MFN 08-232  
Supplement 1

**Subject: Response to Portion of NRC Request for Additional Information  
Letter No. 198 Related to ESBWR Design Certification Application  
– DCD Tier 2 Section 3.7 – Seismic Design – RAI Number 3.7-63  
S01**

**RAI Number 3.7-63 S01**

**Figure 3.7-63(1) Comparison of Surface Response Spectra for Layered Case 2 when the Input Motion is applied at Different Levels**

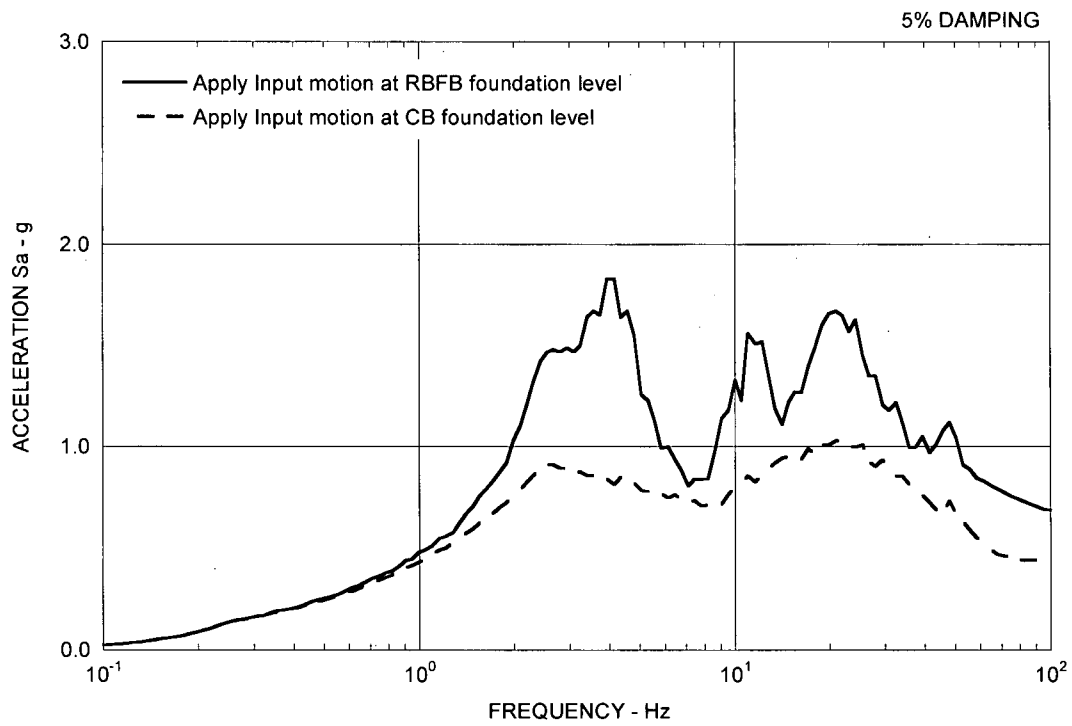
- (a) Based on the first two sentences above, it appears to the staff that the ground motion for the CB was applied at two different elevations: at the CB foundation level for the generic sites defined in Subsection 3A.3.1, and at the RBFB foundation level for the layered site cases. Please confirm this, or clarify what was actually done. If this is the case, please describe what differences in CB response would be expected for the layered site cases if the input ground motion had been defined as an outcrop motion at the CB foundation level.*

*In reviewing Figure 3.7-63(1), the staff noted that the surface spectra corresponding to placing the input motion at the bottom of the CB foundation (dashed line) does not appear to be correct. It resembles the spectrum of the input motion, at the foundation level. The dashed line would be expected to exhibit the same pattern of peaks and valleys as the solid line. GEH needs to confirm that the dashed line is correct, and provide an explanation for the unexpected shape.*

- (a) GEH confirms that the ground motion for the CB was applied at the CB foundation level for the generic site cases and at the RBFB foundation level for the layered site cases.**

Applying the outcrop motion at the RBFB foundation level for the layered site cases is a more conservative approach than applying the outcrop motion directly at the CB foundation level. This is demonstrated in Figure 3.7-63(1) by comparing the response spectra of the surface motion when the ground motion is applied at the RBFB foundation level and at the CB foundation level for the typical layered site Case 2 described in DCD Tier 2 Table 3A.3-3. The response spectrum of the surface motion is larger in the case when the ground motion

is applied at the RBFB foundation level than in the case when the ground motion is applied at the CB foundation level. Therefore, it is expected that the CB response would be smaller for the layered site cases if the input ground motion had been defined as an outcrop motion at the CB foundation level instead at the RBFB foundation level.

GEH confirms that both the solid and dashed lines in Figure 3.7-63(1) have been correctly calculated by using the method identified as the DCD Method in GEH's response to NRC RAI 3.7-16, Supplement 2 transmitted to the NRC via MFN 06-274, Supplement 2, which includes the entire soil column up to the ground surface in a single SHAKE run with outcrop motion input at the foundation level.

The reason for the dashed line resembling the foundation input spectrum is because the CB (14.9 m embedment) is shallower than the top layer (20m thick) of the layered sites (see DCD Tier 2 Table 3A.3-3). In other words, the soil properties above the foundation are the same as those below the foundation in the region of the top layer and, as a result, the surface motion resembles the foundation input motion. This can be further explained by the one-dimensional wave propagation theory below:

Figure 3.7-63(2) Comparison of Horizontal SSE Design Response Spectrum with NA3 Site-Specific Spectra at FWSC Foundation Level (Reproduced from North Anna 3 COLA FSAR Figure 2.0-203)

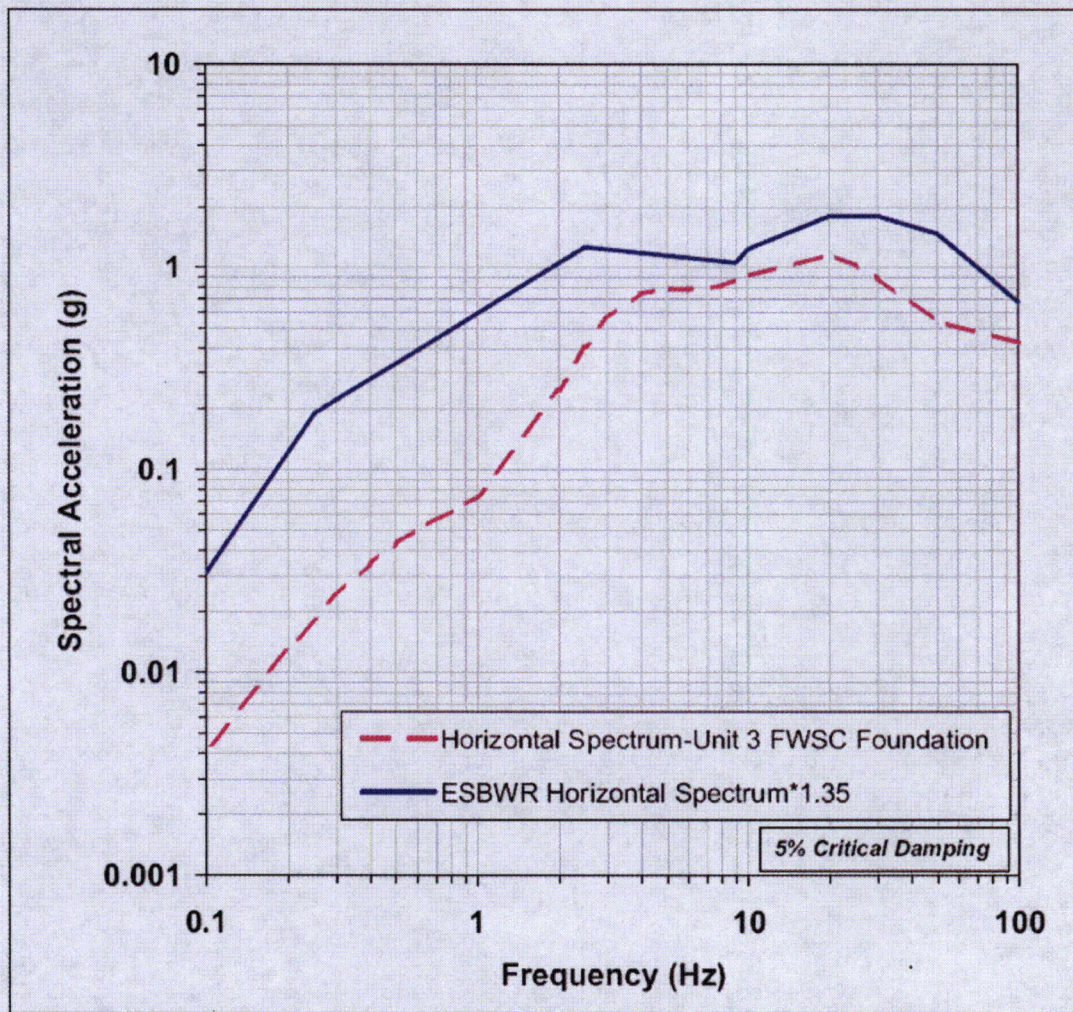
- (b) The third sentence above defines the input ground motion used for the FWSC SSI analyses as “1.35 times the RBFB/CB foundation input motion...applied directly at the foundation level.” Please provide a detailed technical basis for the selection of the 1.35 factor, including pertinent quantitative information upon which this determination is based.*

*The staff believes that the surface spectra used for seismic analysis of the FWSC should envelope the 8 surface spectral plots that the staff has asked GEH to derive under Part (1) above. This would ensure consistency between the input at the RB/FB and CB foundation levels and the input at the surface for the FWSC. GEH's proposed 1.35 factor on the input motion at the bottom of the RB/FB foundation may or may not produce a suitable envelope. Based on comparing Figure 3.7-63(1) to Figure 3.7-63(2), it appears to the staff that a 1.35 factor may not be sufficient over the entire frequency range.*

- (b) The technical basis for scaling the RBFB/CB foundation input motion for ground motions at other depths is to maintain a broad-band spectrum shape that is rich in all frequencies, regardless of site conditions, for the purpose of standard plant design. Broad-band design spectrum at any foundation depth is compatible with smooth site-specific ground motion response spectrum (GMRS) and associated foundation input response spectrum (FIRS) generated in accordance with RG 1.208 requirements for new units. The 1.35 scale factor was determined such that the resulting spectrum at the FWSC foundation level envelops the FIRS at the North Anna 3 site as shown in Figure 3.7-63(2) for the horizontal motion and Figure 3.7-63(3) for the vertical motion.

Figure 3.7-63(4) Comparison of Surface Response Spectra for Layered Case 1

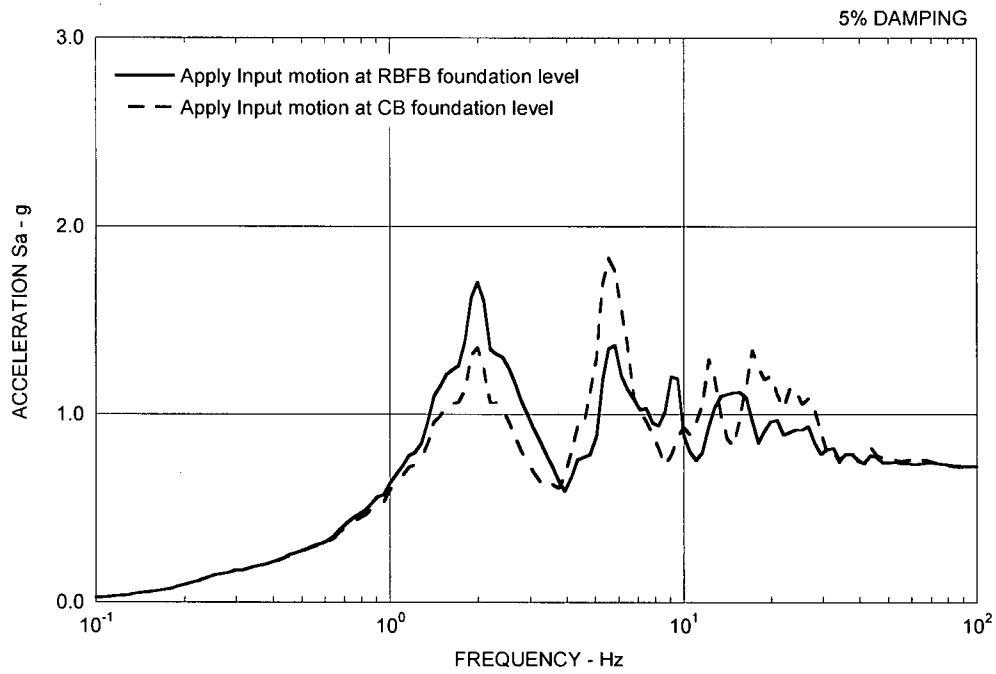
*Part (1) - GEH needs to submit a comparison of the surface spectra derived by placing the input motion at the bottom of the RB/FB foundation to the surface spectra derived by placing the input motion at the bottom of the CB foundation, for each of the 4 SASSI layered soil cases. In deriving the surface spectra from the foundation motions, the method identified as the NRC method in GEH's response to RAI 3.7-16 must be used. Submit four (4) figures, similar to Figure 3.7-63(1).*

Part (1) - Figures 3.7-63(4) through (7) show comparisons of the surface spectra derived by placing the input motion at the bottom of the RB/FB foundation to the surface spectra derived by placing the input motion at the bottom of the CB foundation for each of the 4 SASSI layered soil cases by using the method identified as the NRC Method in GEH's response to NRC RAI 3.7-16, Supplement 2 transmitted to the NRC via MFN 06-274, Supplement 2.

Part (2) - The surface spectra computed from the input spectra defined at the RB/FB and CB foundations, as shown in Figures 3.7-63(4) through 3.7-63(7), exhibit distinct peaks and valleys. Using these surface spectra directly as input motion could under-predict or over-predict the FWSC response depending on the SSI frequencies. The more balanced approach for the standard plant design is to maintain the broad-band characteristics in the foundation input spectra that is rich in all frequencies, regardless of site conditions. This is the technical basis for the selection of FSWC input spectra to be 1.35 times the broad-band Certified Seismic Design Response Spectra (CSDRS) for the RB/FB and CB. As stated in the original response to this RAI, the 1.35 scale factor was chosen to envelop the FWSC Foundation Input Response Spectra (FIRS) at the North Anna 3 site. To ensure the seismic adequacy of the FWSC at each site, the COL applicant is required to compare the site-specific FIRS for the FWSC with the FWSC CSDRS, which is 1.35 times the values shown in DCD Tier 2 Figures 2.0-1 and 2.0-2 as stipulated in footnote 9 to DCD Tier 2 Table 2.0-1.
